N4873A-01

S E R V I C E N O T E

N4873A 13.5 GB/S ANALYZER MODULE

Pro-active –24V fix

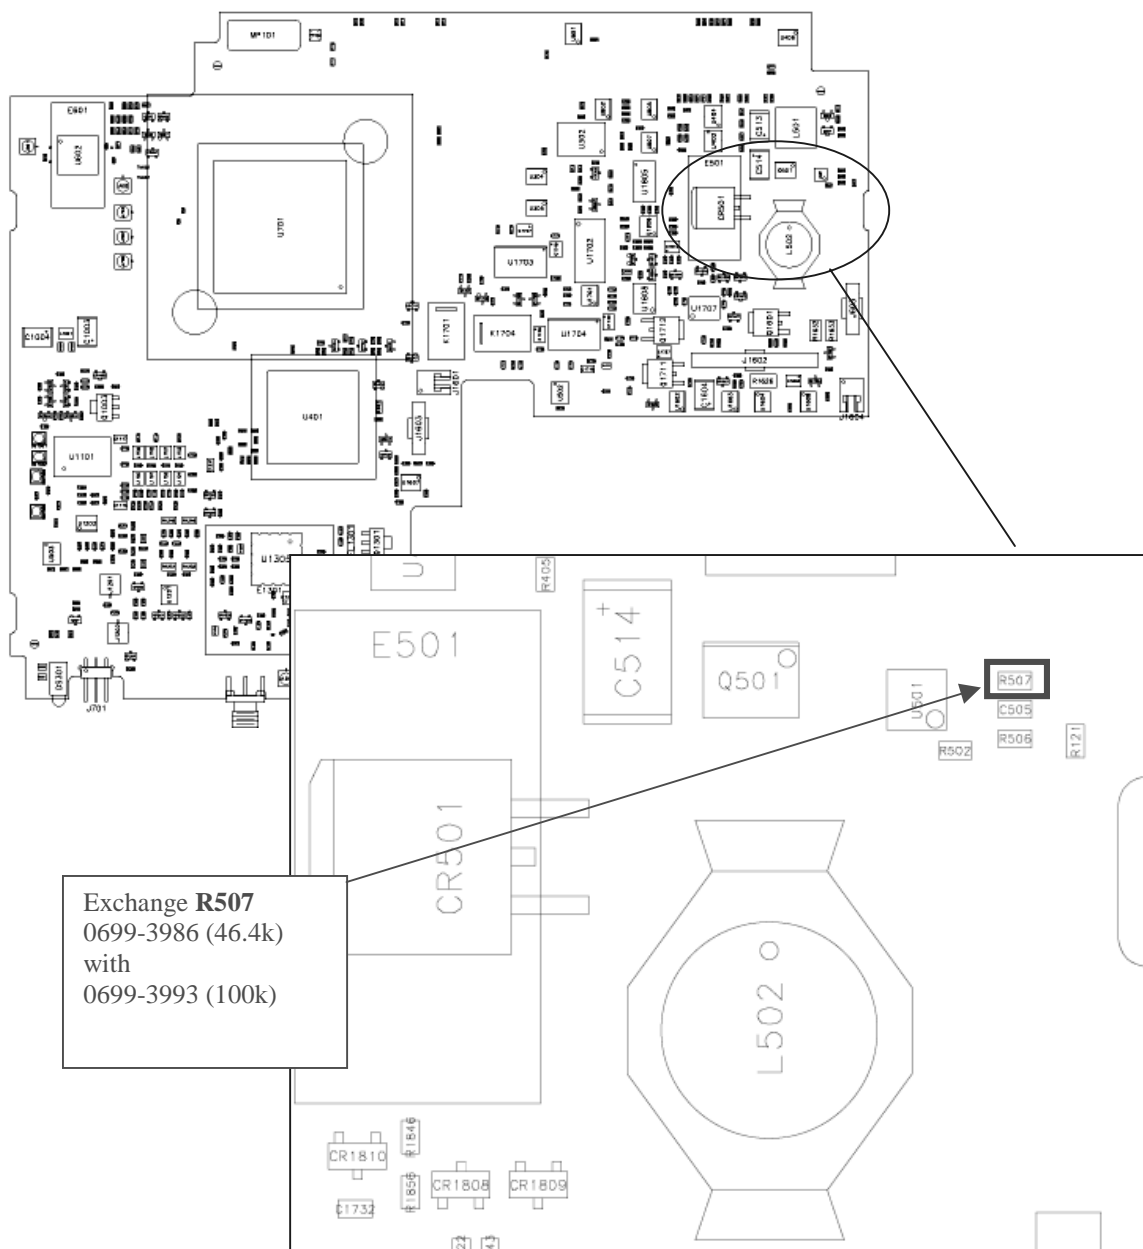
Module draws too much current on -24V in some Mainframes. Resulting from that the -24V fuse blows. The error message “Self-test failed: Voltage of -24V is out of valid range-330” will appear during module self test. If you see this failure, the fix described below is too late. The module needs to be repaired.

Exchange R507 (46.4k) by a 100k resistor on analyzer front-end board N4873-66401 Rev. 100 - Rev. 108 (PCB N4873-26501 Rev. 100 – 102).
